**SAFETY CASE REPORT**

**ADDENDUM**

# **Doel 3**

## **Reactor Pressure Vessel Assessment**

**Figure 2.1: Size of the largest flaws with 20° inclination potentially not reported by UT inspection**

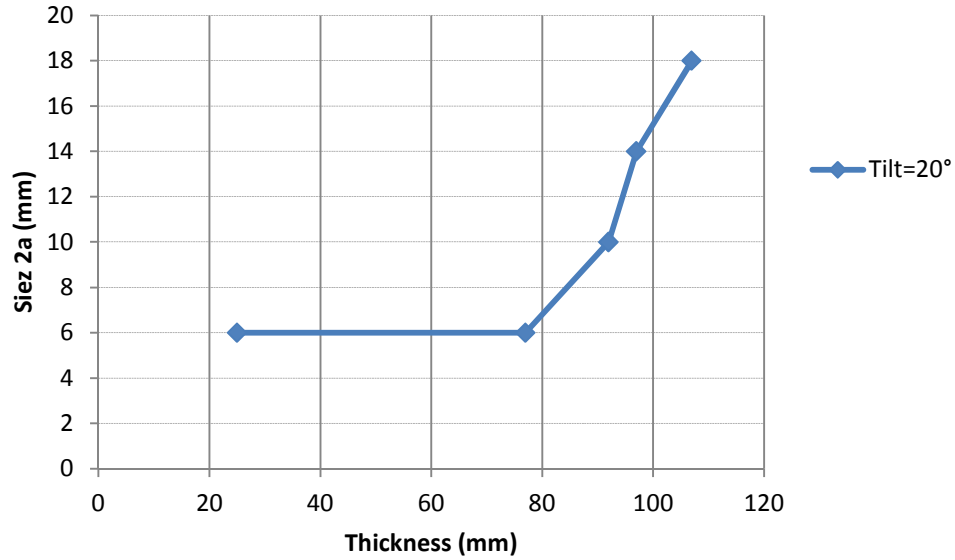
In 'Doel 3 and Tihange 2 reactor pressure vessels – Provisional evaluation report (30 January 2013)', the FANC requires the following with regard to tilted flaws:

*The licensee shall demonstrate that the applied ultrasonic testing procedure allows the detection of the higher tilt defects in the Doel 3/Tihange 2 data (2012 inspections) with a high level of confidence.*

For the depth range between 25 and 120 mm, Figure 2.1 shows the size of the largest flaw with the conservative 20° inclination that would potentially not have been reported, as a function of the position in the RPV wall. The impact that these potentially unreported flaws could have on the results of the Structural Integrity Assessment (SIA) is addressed as part of the Sensitivity Analyses in Chapter 5.

Flaws with an inclination up to 20°—that would potentially not have been reported—have been determined as a function of the position in the RPV wall. These potential flaws are considered in the Structural Integrity Assessment as part of the Sensitivity Analyses (see Chapter 5).

**Figure 3.1: Factors contributing to the creation of hydrogen flakes**

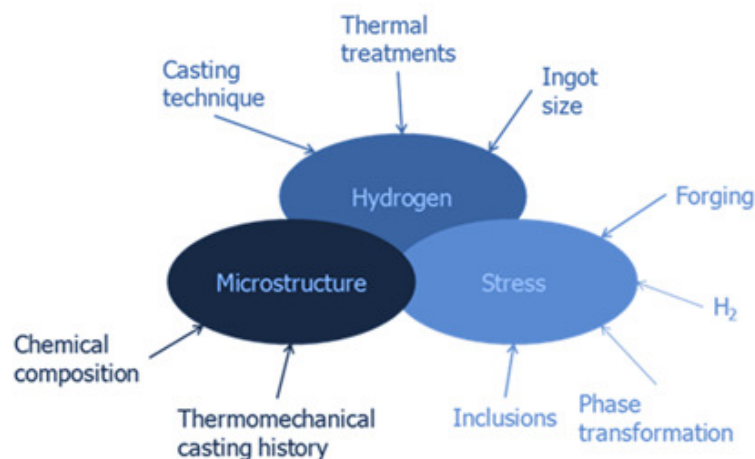
During the discussion of the Safety Case Report, it was noted that the root cause analysis did not explain why the hydrogen-induced degradation did not evenly affect all the forged components of the Doel 3 and Tihange 2 RPVs, though their hydrogen content is comparable.

As explained in the Safety Case Report, there is a consensus in current literature that three factors are necessary for the creation of hydrogen flakes (see Figure 3.1). Each factor is in turn influenced by several parameters.

Casting, forging, and heat treatment are similar for the Doel 3 and Tihange 2 RPVs. A comparison between the forgings can be made based on the few parameters that are different from one component to another, such as ingot size and hydrogen and sulphur contents.

Figure 5.2: Flaw-screening criterion applied to core shells of Doel 3

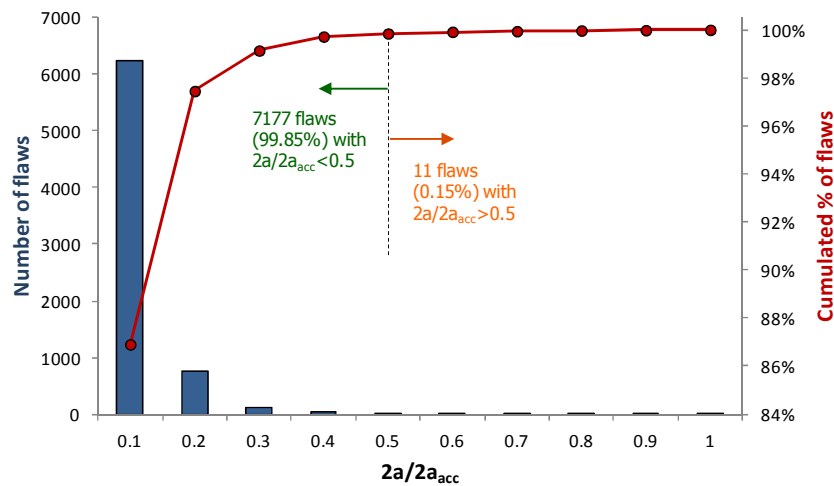
To assess the effects of the high number of detected flaws, Bel V proposed to use a deterministic screening criterion approach. The objective of this approach is to show:

Applying the flaw-screening criterion to the flaws detected in the RPV core shells of Doel 3 shows that eleven flaws (isolated or grouped) exceed the flaw-screening criterion, as illustrated here:

These eleven flaws require further analysis according to Figure 5.1.

Figure 5.6: Sensitivity analysis for  $S \rightarrow 0$  combined with effect of a 5° increase of the inclination of the Doel 3 flaw (Ev2220)

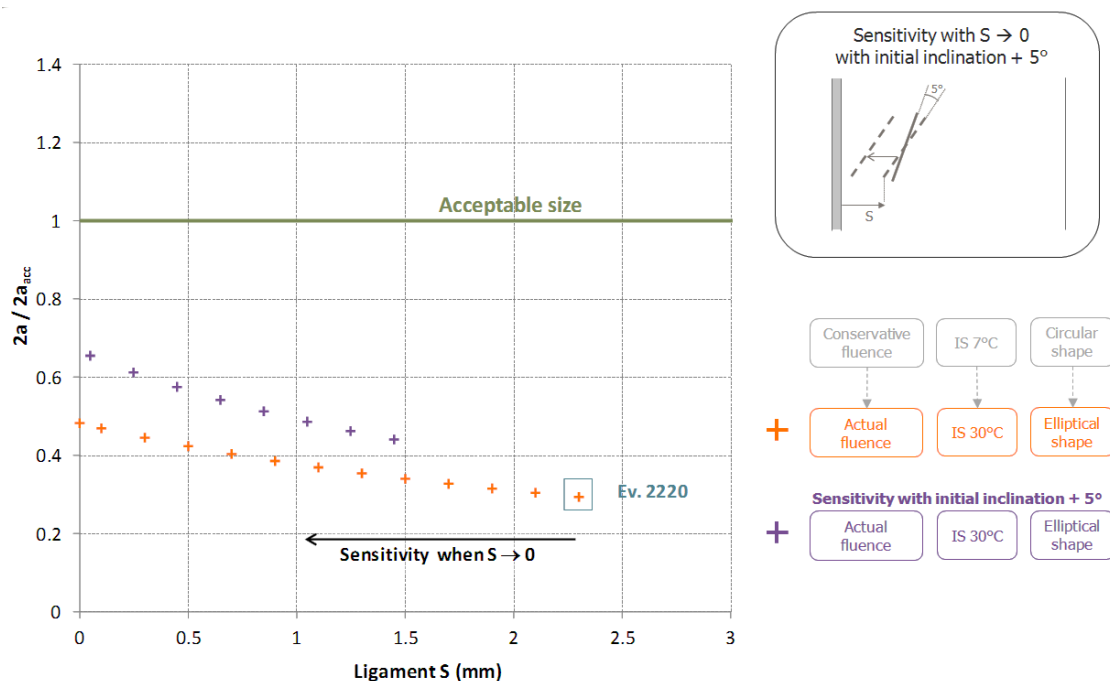
The International Expert Review Board (IERB) required a sensitivity analysis for the location of the flaws in the structural analysis. More specifically, the IERB suggested considering the most critical flaw of the analysis (the Doel 3 flaw Ev2220) and to investigate how the results of the SIA change when the flaw's ligament  $S$  would tend to zero.

A number of sensitivity analyses were performed on the most penalizing flaw of the two RPVs (Doel 3 flaw Ev2220), considering effects such as the ligament tending to zero, a 5° larger inclination, the actual fluence, the flaw shape, and the Safety Injection water temperature. Results confirm that a significant margin remains in all cases. The figure below shows the evolution of the margin with respect to the acceptability criterion with the ligament  $S$  tending to zero.
